# BULLETIN

**Subject:** FedEx Freight 28' Units with Duraplate Roofs

No.: B18017

Re.: Rear Limb Deflector Removal

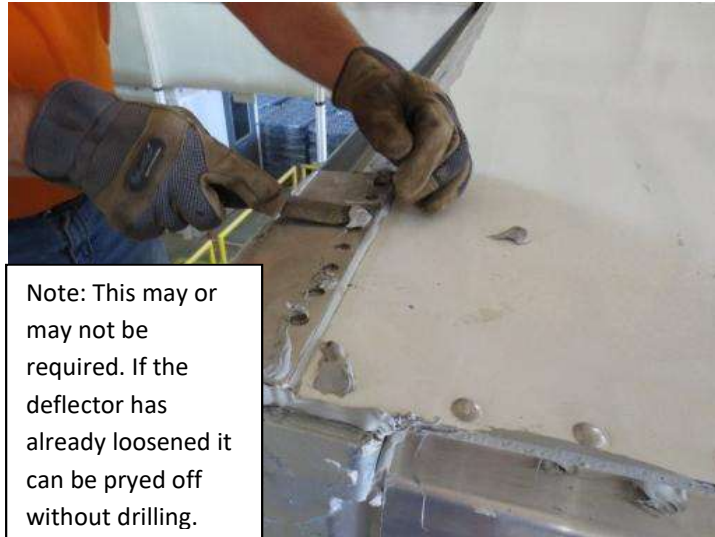
1. Prior to any repairs being completed check for the following conditions. If there is a black paint mark above the VIN tag the repair has already been completed, or if there is a presence of a Tether Bolt going through the upper rear header the repair is not needed.

Notice the black paint dot above the VIN tag indicating that the repair has already been completed. If the black dot is not present it will need to be added once the repair has been completed.

Notice the presence of the Tether Bolt going through the upper rear header indicating that the repair is not needed.

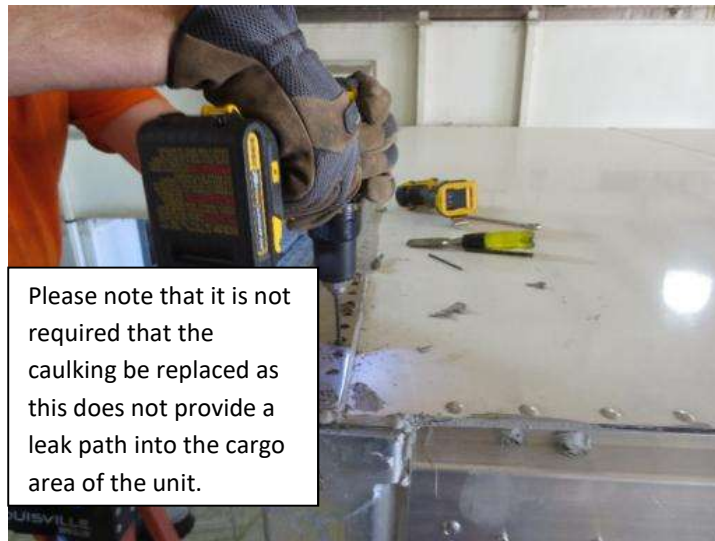
2. Once unit is safely secured, start the repair by using a Putty Knife to remove the caulking from the heads of the existing rivets.

Note: This may or may not be required. If the deflector has already loosened it can be pried off without drilling.

3. Using a 3/16" drill bit, drill out and remove the 4 existing rivets.
